HISTORIC AND DESIGN REVIEW COMMISSION

October 19, 2022

HDRC CASE NO: 2022-520
ADDRESS: 424 CLUB DR
LEGAL DESCRIPTION: NCB 7013 BLK LOT W 60 FT OF 4
ZONING: RM-4, H
CITY COUNCIL DIST.: 7
DISTRICT: Monticello Park Historic District
APPLICANT: Mark Ramirez
OWNER: TRIO INVESTMENT PARTNERS LLC
TYPE OF WORK: window replacement and fenestration changes, construction of a rear two-story deck
APPLICATION RECEIVED: September 23, 2022
60-DAY REVIEW: Not applicable due to City Council Emergency Orders
CASE MANAGER: Jessica Anderson
REQUEST:

AN ADDITION AT
424 CLUB DR.
MONTICELLO PARK
SAN ANTONIO, TX

FLOOR PLANS
ELEVATIONS

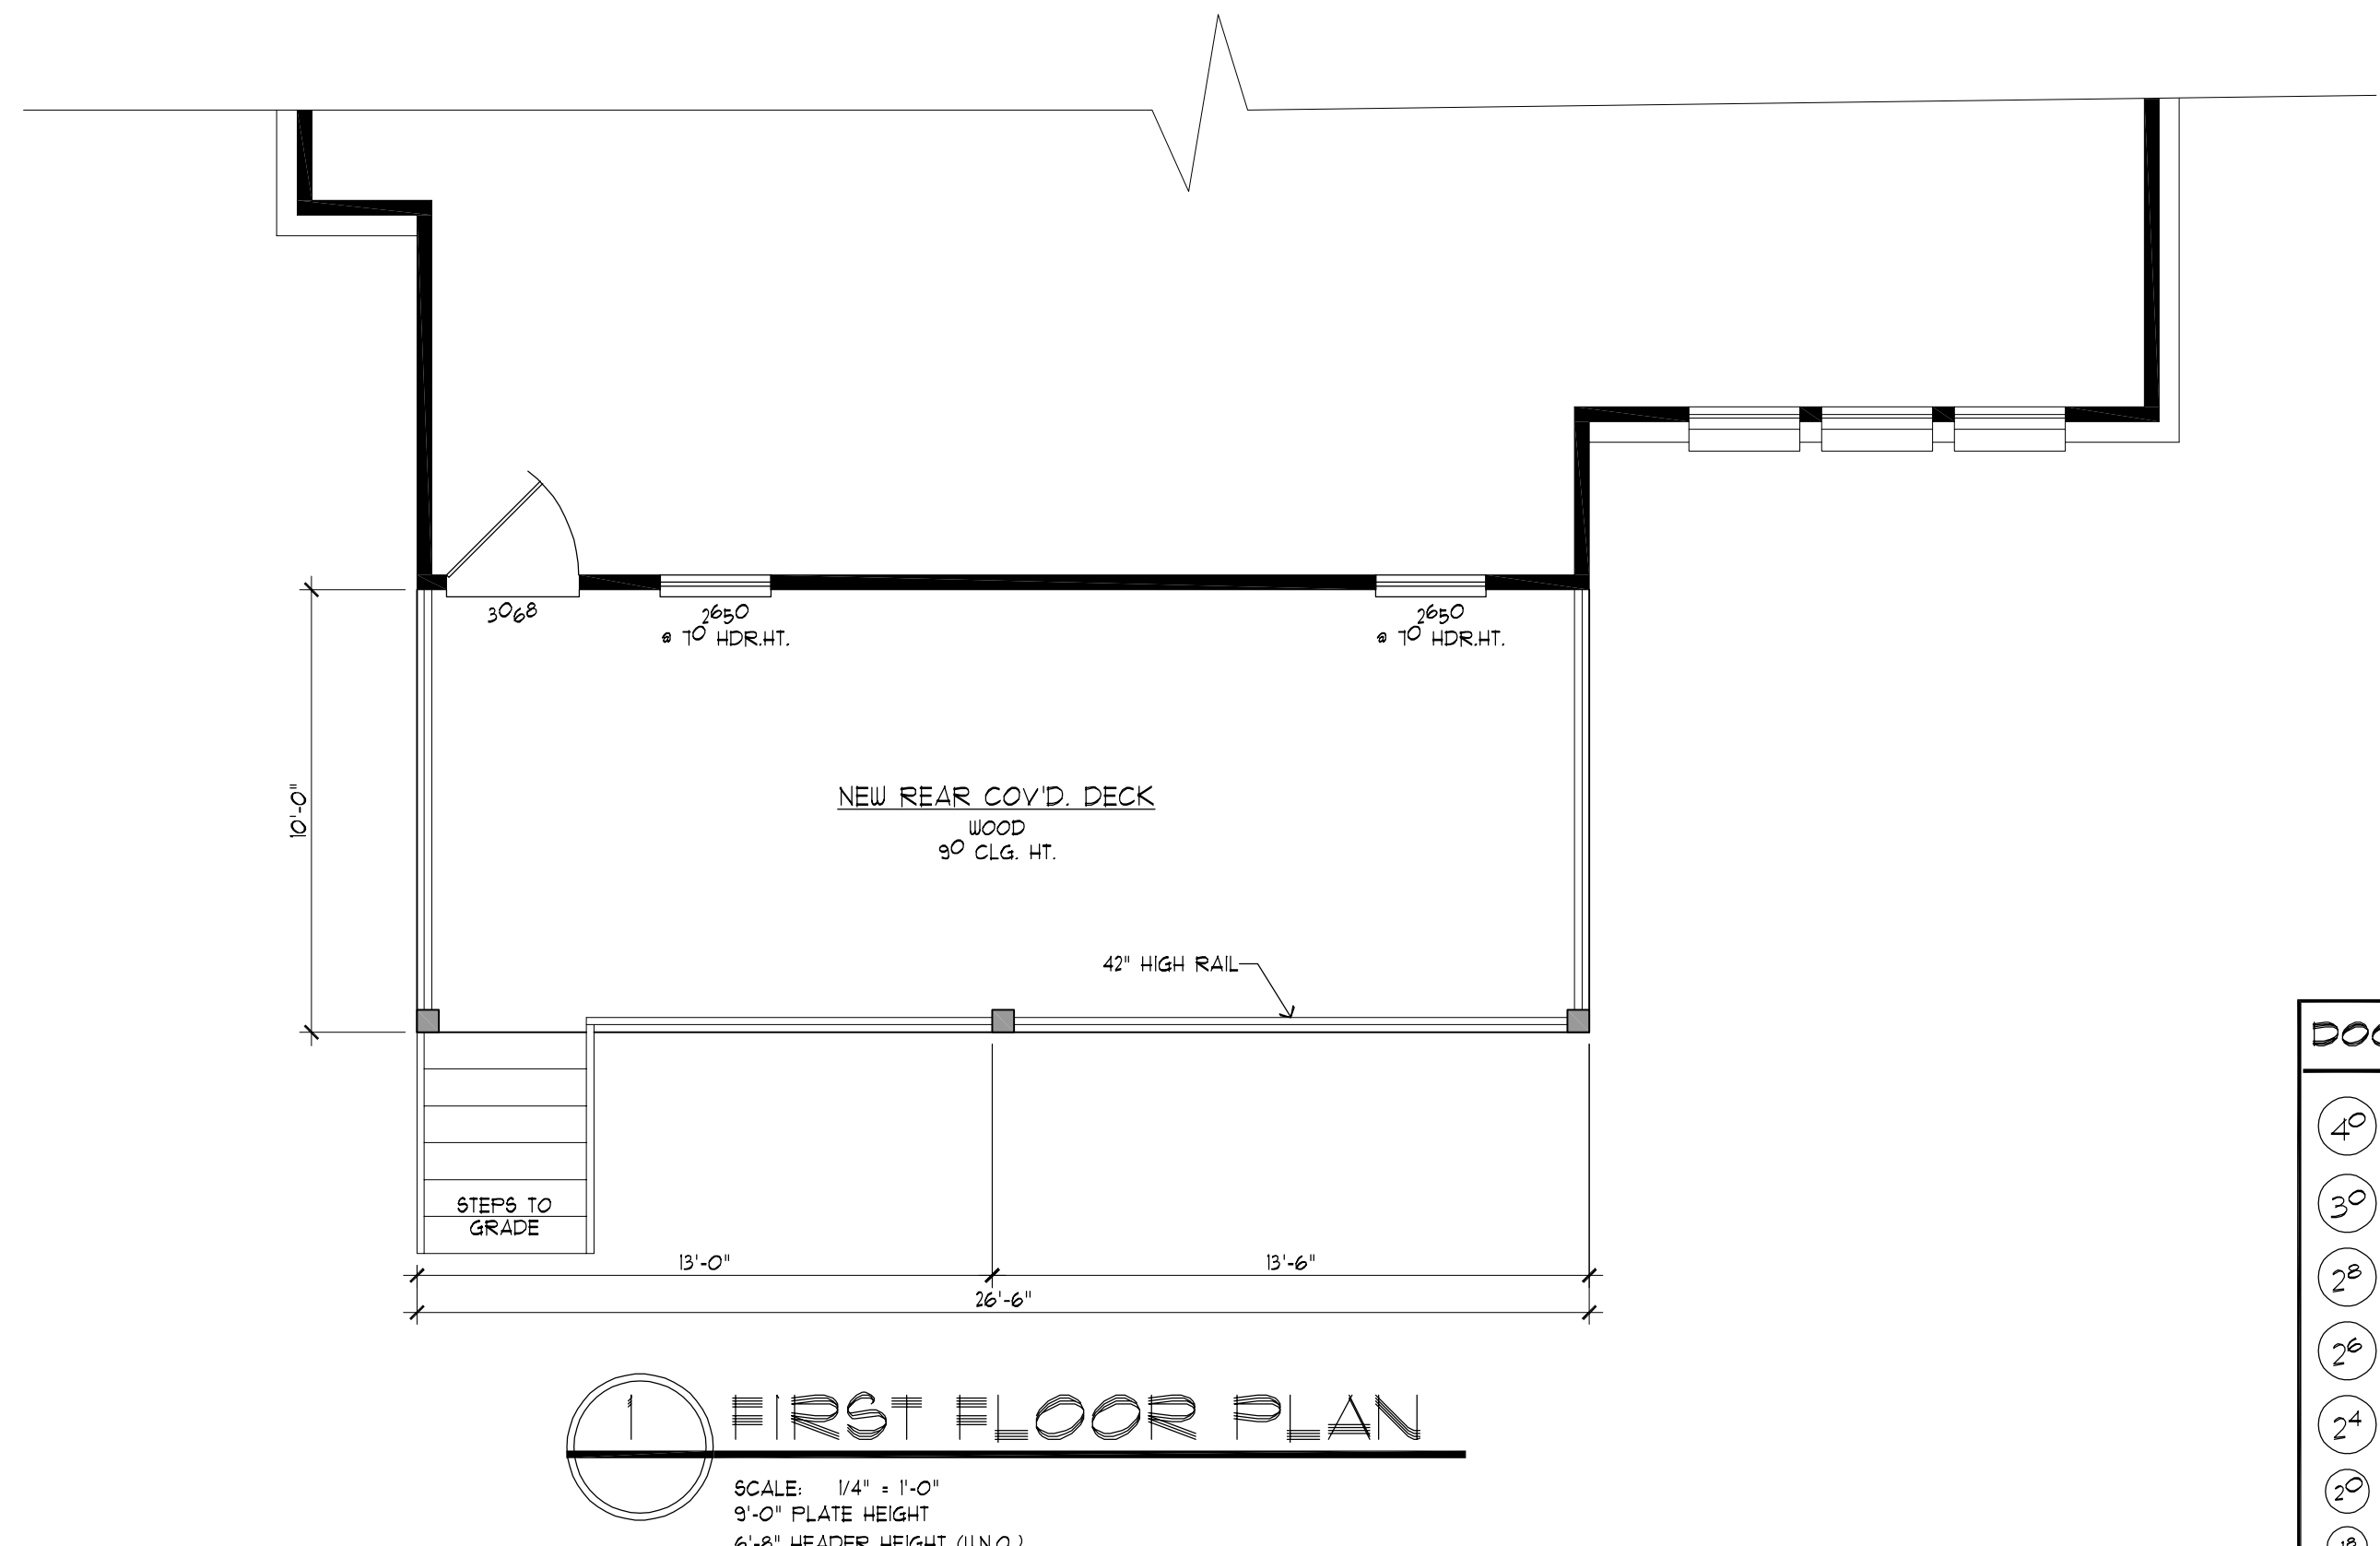
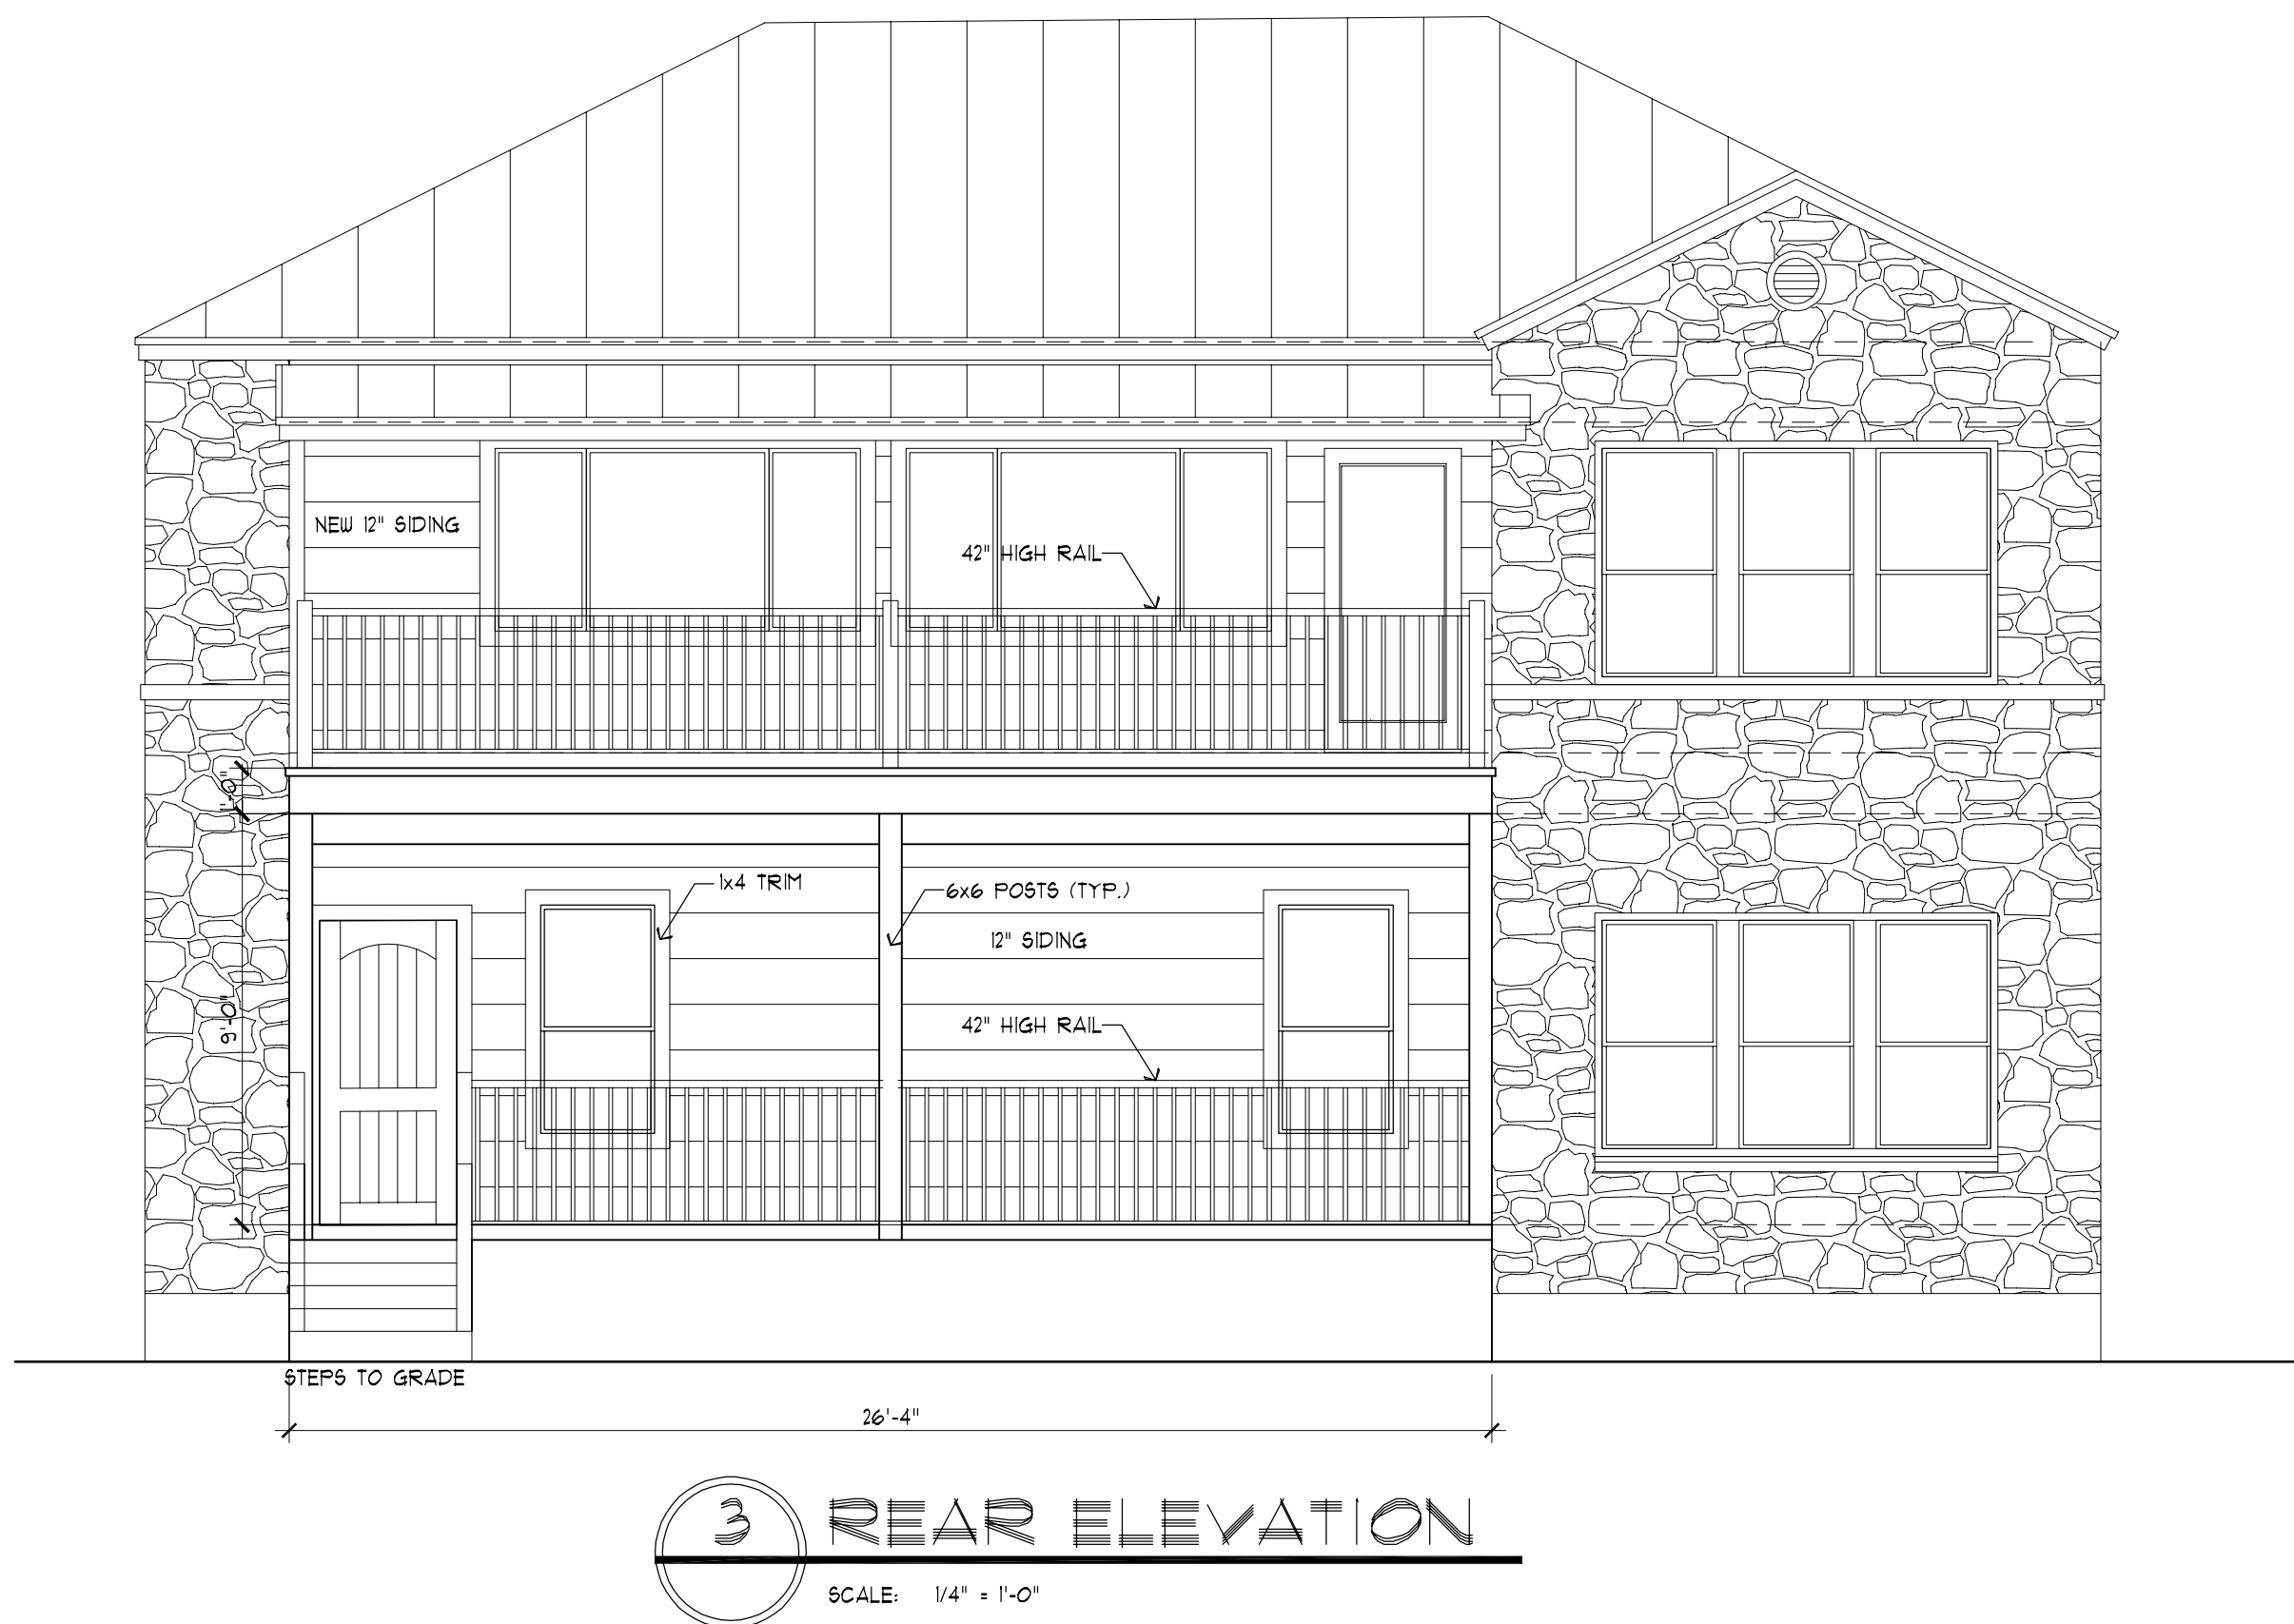
- e. **ADDITION: REAR PORCH:** The applicant requests approval to construct a two-story rear porch and to restore a door at the east end of the second floor of existing enclosed porch. Historic Design Guidelines for Exterior Maintenance and Alterations 7.B.v states that porches, balconies, and porte-cocheres should be reconstructed based on accurate evidence of the original, such as photographs. If no such evidence exists, the design should be based on the architectural style of the building and historic patterns. Staff finds the porch conforms to guidelines and that returning the second-floor door is appropriate. The applicant must ensure the new porch conforms to all setback guidelines as defined by UDC.

- f. **FENESTRATION CHANGES:** The applicant requests approval to remove one door from the primary elevation and replace it with a one-over-one window. Historic Design Guidelines for Exterior Maintenance and Alterations 6.A.i and ii state that historic doors and windows should be preserved. Staff finds the proposed door removal does not conform to guidelines.

Staff recommends approval of item 3, construction of a two-story rear porch and return of the rear second-floor door, based on finding e, with the following stipulation:

- i. That the applicant meet all setback requires as defined by UDC.

Staff does not recommend approval of item 4, replacement of one front door with a window, based on finding f.
